# SCIENCE REVIEW OF THE PHASE 2 ADDENDUM TO THE FINAL ENVIRONMENTAL IMPACT STATEMENT FOR THE BAFFINLAND MARY RIVER PROJECT

This Science Response Report results from the Science Response Process held February 5, 2019 on the Science Review of the Final Environmental Impact Statement Addendum for the Baffinland Mary River Project Phase 2.

Figure 2. Northern shipping route, including waypoints and anchorage locations.

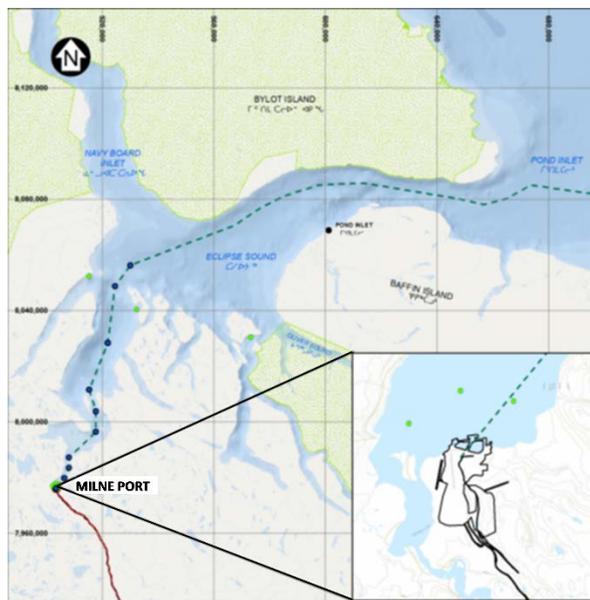
DFO feels that further information on the drift zones would be required to determine any potential effects to the marine ecosystem, including risks to marine mammals or other environmental effects associated with large ships drifting (e.g., potential increase of collisions, change in effects of engine noise, marine mammal occurrence, sensitive benthic habitats). Proposed mitigation measures would also need to be identified in order to address any identified risks. The purpose of the drift zones are not well described; for example, will the area be used as a waiting area if all anchorage locations are taken (if so, for how long) or only in case of emergencies.

- Conduct an assessment of the potential effects to the marine ecosystem resulting from the use of project anchoring locations (Figure 2) and drifting locations. BIM should explain if they plan on establishing any other anchorages and/or if there are any plans to increase the size of the drift zone. How will ship schedules be managed to ensure there are enough available anchoring locations within Eclipse and Milne?
- Video surveys and field surveys should be conducted to establish bottom type and potential sensitive species or habitat use in the anchoring areas prior to project operations, during and post-project completion.
- Permanent moorings should be considered at anchoring locations and throughout the shipping route to compare relative impacts to the marine ecosystem.

Figure 3. Noise propagation from a Cape sized Carrier travelling at Koluktoo Bay/Bruce Head (left panel) and Milne Inlet (right panel)(Figure 2.2 from TSD24, Section 2.6.2.2, p. 46).

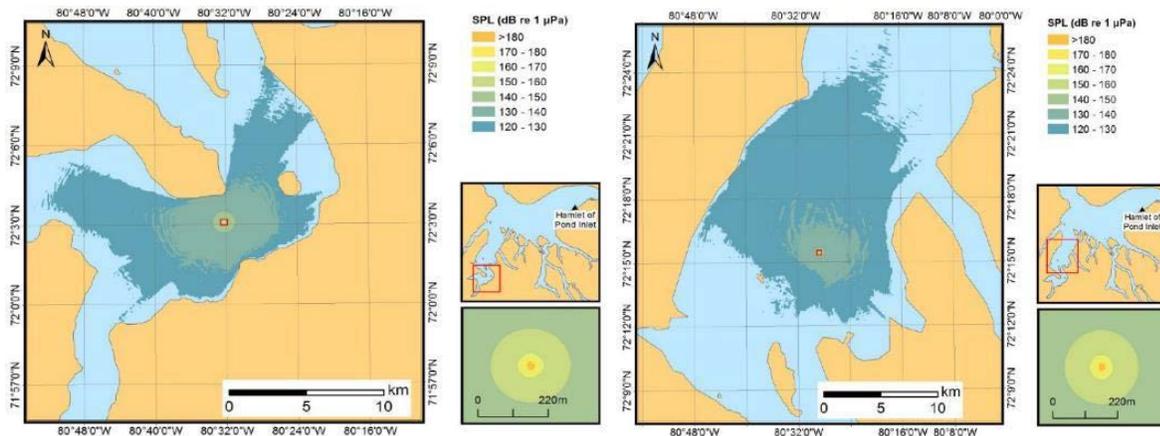
DFO would also like BIM to clarify “short duration [of noise]”, based on the number of ships entering and departing Milne Inlet and the unspecified time idling and drifting, the noise in the LSA appears to be extensive (i.e., non-stop). How does BIM conclude that vessel noise is short duration? BIM also states that “Masking effects on Bowhead were predicted to be localized in Milne Port, and short-term along the shipping route relative to the interval between ship transits.” (TSD24, Section 2.1.4, p. 25). DFO Science would like clarification as to what is the interval between ship transits. Understanding the ratio of quiet hours to when vessels are present is useful information for an accurate assessment.

Figure 4. Marine mammal local (left) and regional (right) study areas, as defined by Baffinland in TSD24, Figures 1.3 and 1.4.

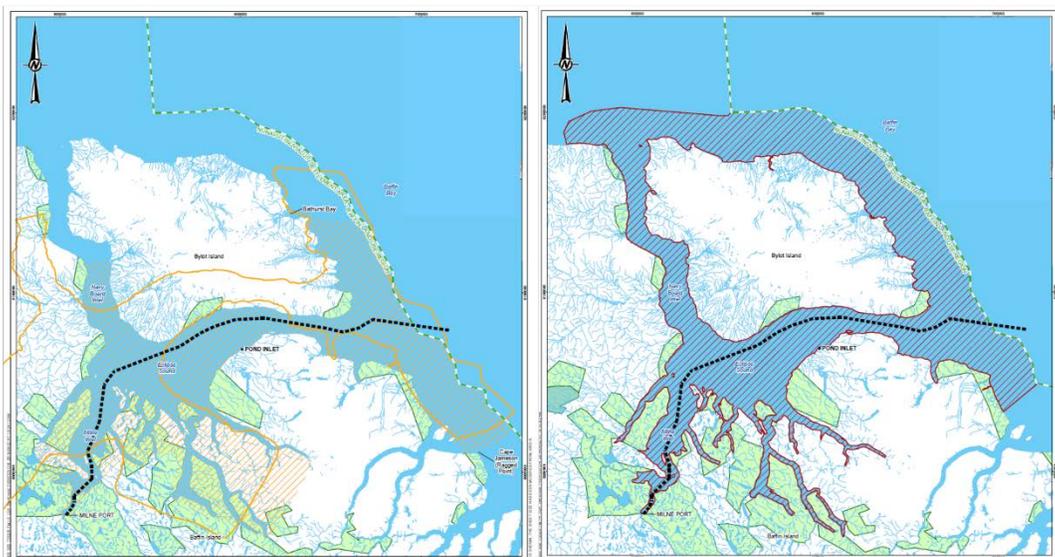
DFO is not confident that the sound mitigation measures identified by BIM will be effective, particularly for those large ships that transmit sound from shore to shore in narrow areas of the shipping corridor (Figure 3). In addition, based on the data presented in the 2017 Bruce Head Shore-based Monitoring Program (Report No. 1663724-041-R-Rev0, Table 5-1, p.44), a number of the project-related vessels exceeded 9 knots within the RSA and LSA (Figure 4).

DFO Science believes the scope of the Regional Study Area (RSA) is too restrictive (Figure 4). It should include Baffin Bay, where ships heading to Europe will transit. Marine mammals such as Bowhead and Narwhal are known to overwinter in Baffin Bay, and transit from the high arctic via the Baffin Island coastline.
